Subject: Response to Request for Additional Information Related to License Amendment  
Request to Incorporate Tornado Missile Risk Evaluator into the Licensing Basis

Arkansas Nuclear One, Units 1 and 2  
NRC Docket Nos. 50-313 and 50-368  
Renewed Facility Operating License Nos. DPR-51 and NPF-6

**Response to Request for Additional Information Related to Proposed Adoption of a  
Tornado Missile Risk Evaluator**

A simplified drawing of the SW supply and cross-tie configuration is provided below:

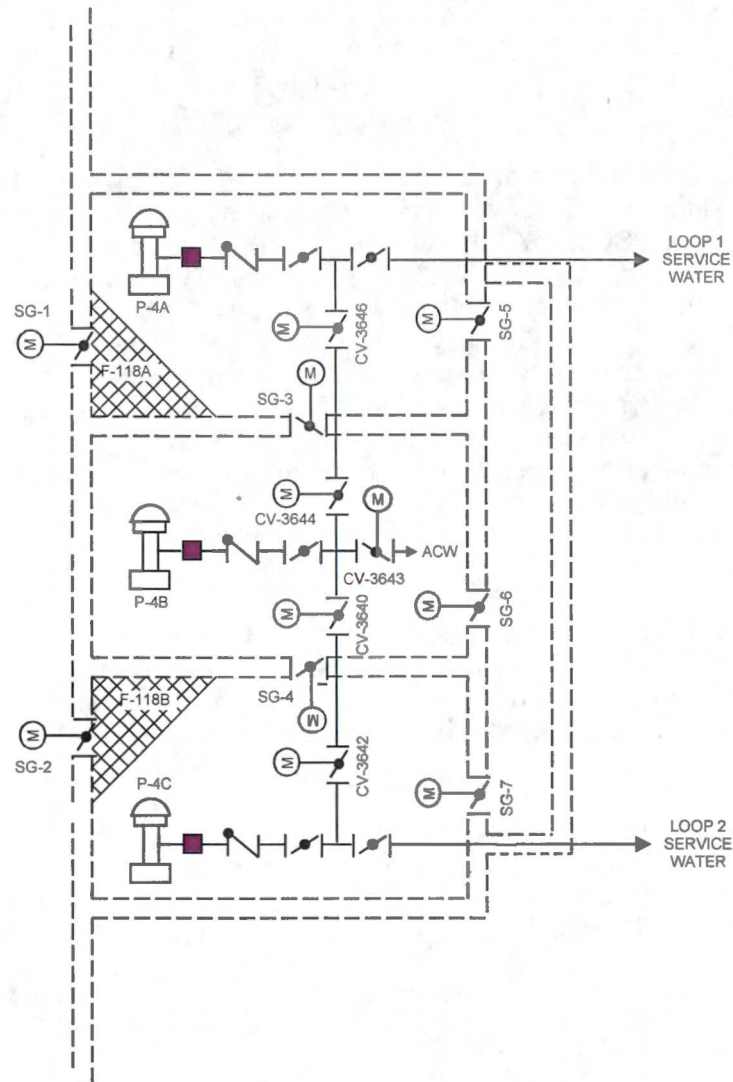
- a. Clarify the statement that the TMRE PRA analysis demonstrates that the SW and EFW systems will remain "functional" following impact from a tornado-generated missile.
- b. Justify how the use of "functionality" in a PRA model is consistent with the guidance on the DID considerations described in Section C.2.1.1.3 of RG 1.174, Revision 3, to meet the second key principle of risk-informed regulation. Alternately, provide a basis that does not rely on PRA "functionality" for why DID continues to be maintained despite the apparent CCFs of the SW and EFW systems.

Should P-4C be failed, the opposite train pump, nominally P-4A, would remain available. The swing SW pump, P-4B, would also remain available. Availability of P-4B is subject to the initial alignment. It may be running initially in which case no impact to SW system operation would occur. Alternatively, P-4B could be aligned in standby to either train. If aligned in standby to P-4A, then realignment to P-4C would be required with operation subject to the impacts discussed below for sluice gate alignment. If aligned in standby to P-4C, then operation could occur almost immediately.

Failure of valves CV-2806 and CV-3851 would prevent alignment of Loop 2 SW to EFW pump P-7A from the main Control Room. However, local operation of these valves would be possible. Although Loop 2 SW to EFW pump P-7A would not be available, this function would not be needed for several hours after the initial reactor trip. Additionally, Loop 1 SW to EFW pump P-7B would remain available.

Valves CV-3644, CV-3642, CV-3640, and CV-3646 are the SW loop cross-tie valves and are used to separate the Loop 1 and Loop 2 SW headers. These valves receive a signal to close on an Engineered Safeguards (ES) actuation. ES actuation is associated with RCS and/or Reactor Building pressure parameters. Following a tornado with coincident LOOP, an ES actuation is not assumed. Therefore, closure of these valves would not be demanded.

**FIGURE 2**  
**PENETRATIONS RESULTING IN VULNERABLE SSCs IN ROOM 129**  
(Control Room – Looking South)

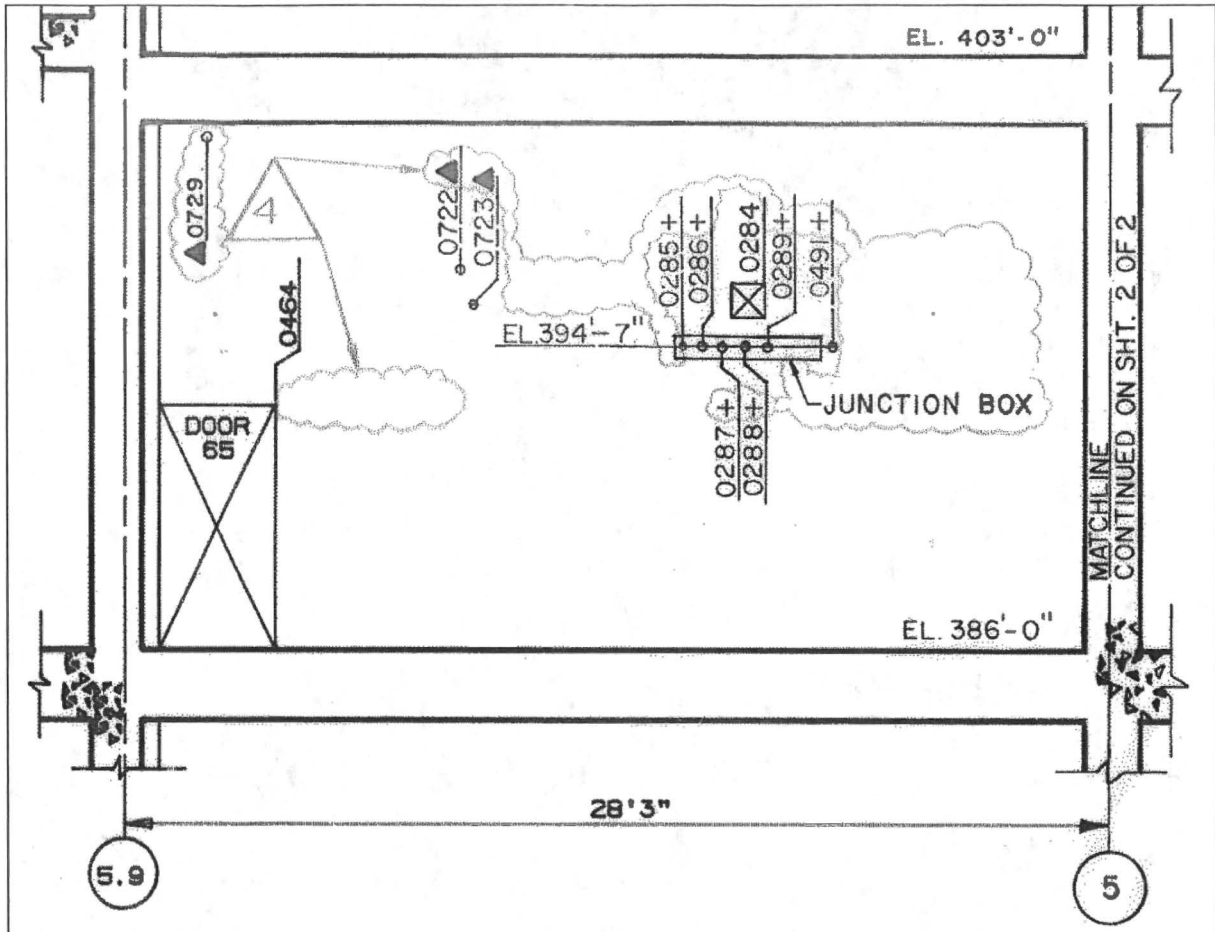
- c. Describe the SSCs that are considered as being impacted by tornado-generated missiles in Room 129 (Control Room), Room 98 (Corridor) and Room 97 (Cable Spreading Room) and their modeling in the TMRE PRA (i.e., what SSCs the single basic event for the rooms represents).
- d. Justify how simultaneous challenges to multiple barriers is avoided and consequently, DID is maintained given the insights from the ANO-1 TMRE PRA model base results as well as the "ANO-1 Single Event Cutset Sensitivity." The justification should include details about any conservatisms in modeling the impact of tornado-generated missiles as well as resulting failures of relevant SSCs in Room 129 (Control Room), Room 98 (Corridor) and Room 97 (Cable Spreading Room).

As shown in Attachment 2, Figure 2, of this enclosure, the modeled vulnerabilities in the Control Room include several penetrations in the southern exterior wall (FB-129-6), which include Door 65. The intervening structures outside of this wall include several grouted block walls to the south and east. A tornado missile protection modification has been installed that reinforces the grouted block walls and adds a 5/16" steel plate to the exterior of the controlled access area. Because this modification does not meet the NEI 17-02 criteria of 1" of steel plating and it is not clear from the NEI 17-02 guidance whether a combination of 5/16" steel plate and a reinforced block wall is sufficient to prevent missile penetration, the modification was not credited in the TMRE analysis. The tornado resistance of the plated, reinforced, grouted block walls was determined to be adequate per the licensing basis. A separate part of the modification installed a 1" steel plating around Stairwell No. 3 that can be credited as part of the TMRE analysis. Additionally, the moisture separator reheaters (MSRs) are large robust components that may be credited for the TMRE analysis.
